Model DVT2 change to Model DVT3 change note list as below:

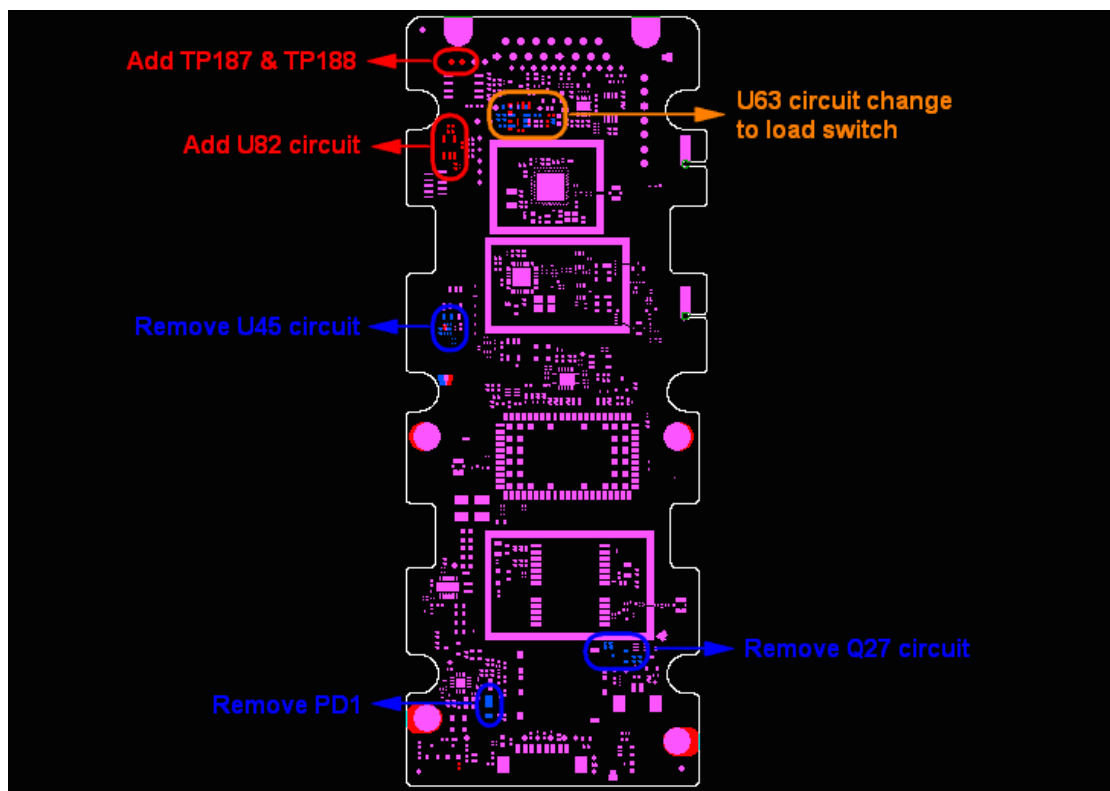
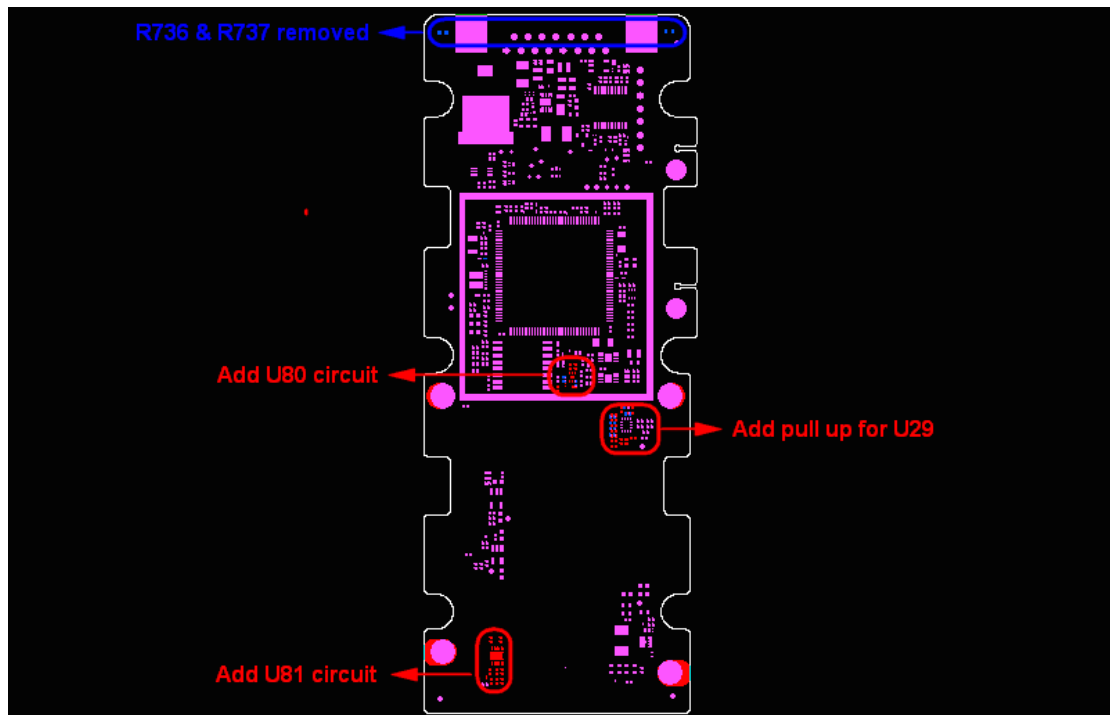
1. Remove R736 & R737: Let D-SUB connector positioning post is directly connected with the earth board, to improve ESD protection.
2. Add U80: U80 is a load switch, as the power switch U3 EEPROM, the EEPROM may do so SW RESET.

3. Add pull up resistor for U29: as amended board when in standby mode, SPI signal level is unknown U29 have a chance to cause the problem of increased current consumption.

4. Add U81: power MUX for Charger , charging power supply would solve two mutually leakage problems.
5. Add U82: For SW increased demand Vehicle power detect circuit.

6. Change U63 to Load switch: LDO primary circuit, always on if there is excess power consumption due LDO characteristics, so to Switch Load.
7. The the Remove U45: SW changes, do not need to switch U45 load switch.

8. Remove Q27 & PD1: substituted U81 Power MUX.
9. This RF module F/W will upgrade version (open B25 product but customers will disabled by software)
